Application/Control Number: 10/686,733

This is the **Final Office Action** for application number 10/686,733 Touch Panel Holder Frame, Spacer Member and Display, filed on 10/17/03. Claims 1-10 are pending. This **Final Office Action** is in response to applicant's reply dated 12/20/04. The text of those sections of Title 35, U.S. Code not included in this action can be found in a prior Office action.

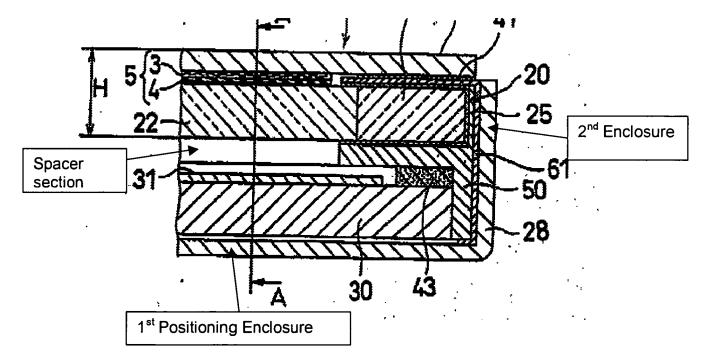
The publication to Kawashima et al. teaches a first integrated positioning noncellular resin frame enclosure (See Drawing) attached to an electronic display body (30) and a second positioning enclosure attached to a touch panel (10) and a plurality of Application/Control Number: 10/686,733

made from non-cellular resin (See paragraph 0012 for material) holding pawl sections (50), which have a T-shaped cross section which the T-shapes form a first and second enclosures and is provided on an inner surface of the second enclosure wherein the holding pawl sections provide an integrated spacer section (See Drawing Below) that extends between the first and second positioning enclosures to define a given clearance between the display screen and the touch panel, the pawl section which includes a holding section (middle).
